### **CONSTRUCTION SUMMARY**

## Lindsay 2017 Developments Inc. / Sugarwood

# Lot/Unit: 9 Phase/Building: 1 Model/Floor Plan: Catchacoma Lake (4205) Elev A 4Bed 2.5Bath

SCHEDULE "B-1"
Floor Plan

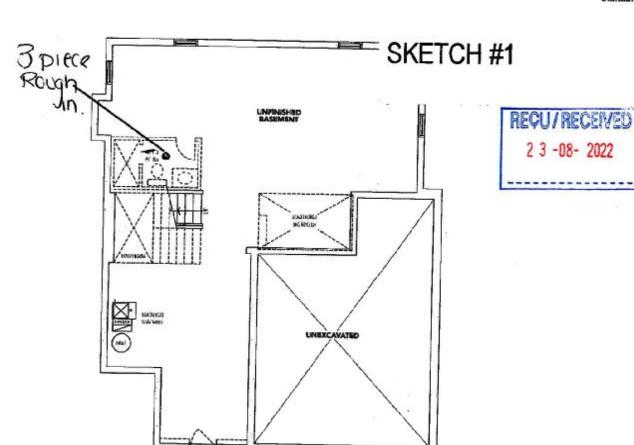
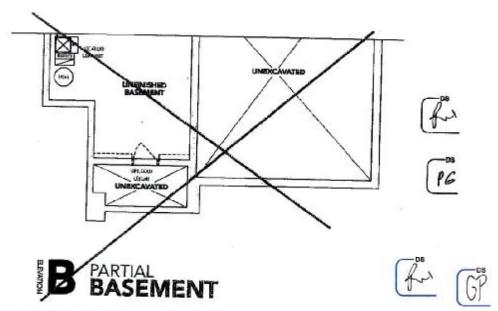
Inv. <b>5751</b>	1 - To supply and install the optional cold cellar in the basement see sketch #1	
Line 73515	Note: NOTE: THIS UPGRADE IS TO BE COMPLETED BY THE CONCRETE AND DRAIN	
	COMPANY	
23Aug22 / 23Aug22

Inv. <b>5751</b>	<b>1</b> - To supply and install the toe tester in the master ensuite shower at approx. 20" from the unfinished floor, in lieu of the standard height	
Line 73516	Note:	
23Aug22 / 23Aug22		
Inv. <b>5751</b>	1 - To supply and install the optional three piece rough-in in the basement see sketch #1	
Line 73514	Note:	
23Aug22 / 23Aug22
